Re: Initial Submission Review - J D Byrider (Jordan Motors) - Conditional Use
Application Number: **DA-1152-03**
Case Number: **1997-6088-06**

First Submission Review

On-Site Parking Per Approved Site Plan

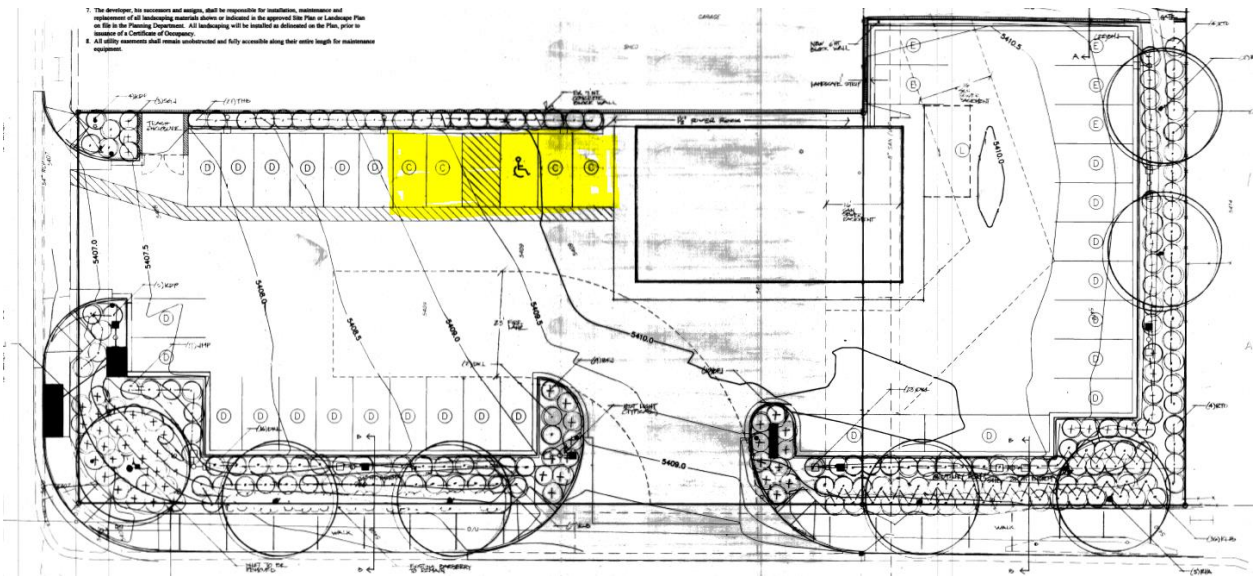
- Re-Striping: Per the Letter of Introduction, the applicant intends to re-surface the existing parking area. Please note that the 1997 site plan was approved with a waiver to reduce the parking stall length and width from 19’ to 17’ and 8.5’ to 8.0’. When the parking area is re-striped, please ensure that parking spaces designated for display are sized at 17’x8.0’ (consistent with the approved waiver), and as conditions allow, customer parking should meet current width requirements of 8.5’. Please revise the Letter of Introduction to verbalize this intent.

- **Inventory Parking:** The Operations/Business Plan outlines an intent to have an inventory of 35-45 vehicles for sale at the 590 North Havana Street property. Per the approved site plan, there are only 36 on-site parking spaces provided at the subject property. Per correspondence with the applicant, this inventory is representational of another operation under the same ownership and the Operations/Business Plan for the 590 North Havana location will be revised so that the proposed vehicle inventory is accommodated with the existing site conditions.

J.D. Byrider Original Landscape Plan

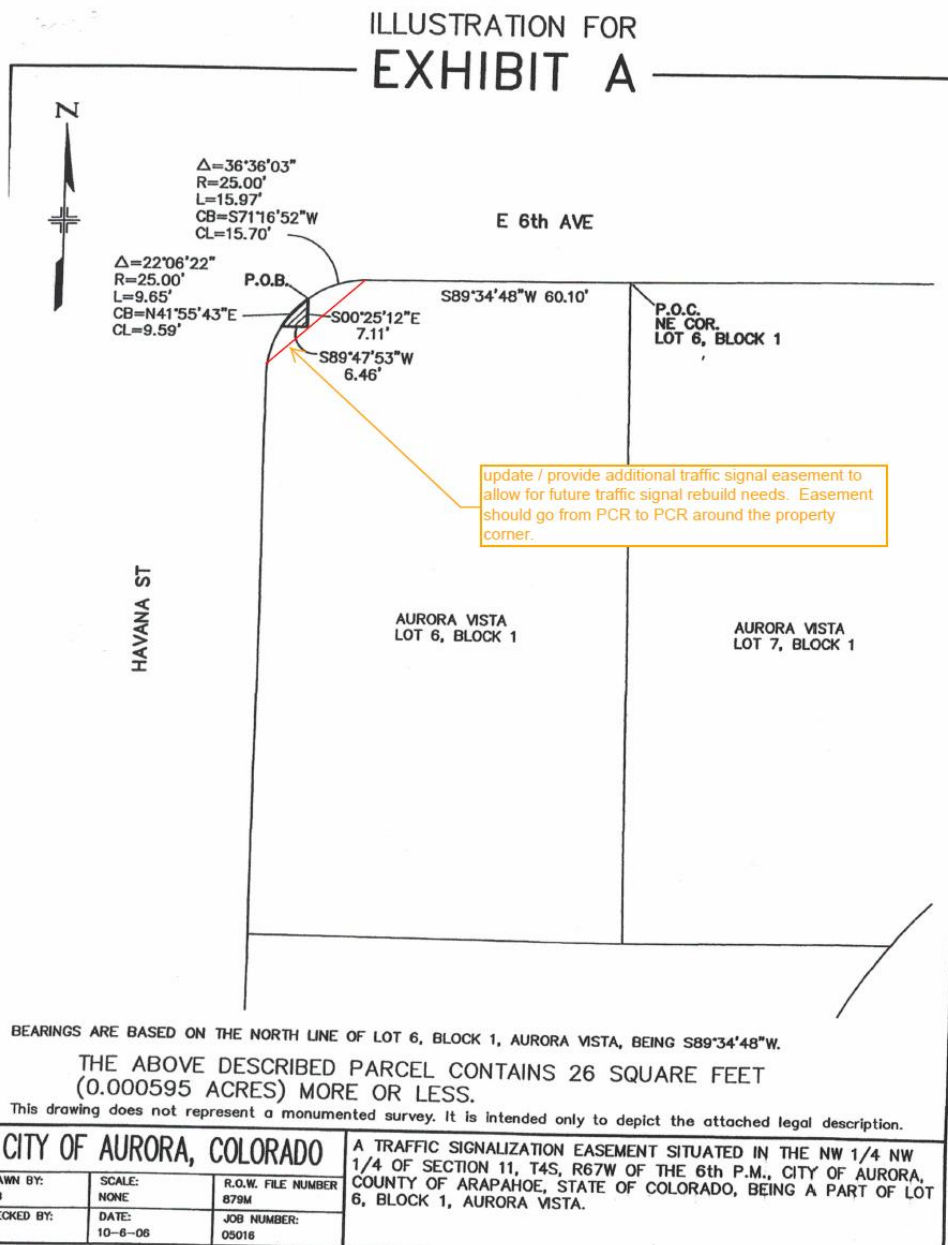
- The applicant in their response to the pre-application review comments has indicated that they intend to conform to the landscape design in the original site plan. This would include the installation of the missing shrub material as noted on the original landscape plan along Havana Street and the eastern property boundary. See the mark-ups on the original landscape plan attached to this letter.
- Also important to note is that the existing street trees should not be removed in an attempt to provide perceived enhanced visibility into the site. Street trees are required per the zoning code and the Havana Overlay District. Removal of street trees will result in the payment of tree mitigation fees and the installation of new street trees to meet code requirements.
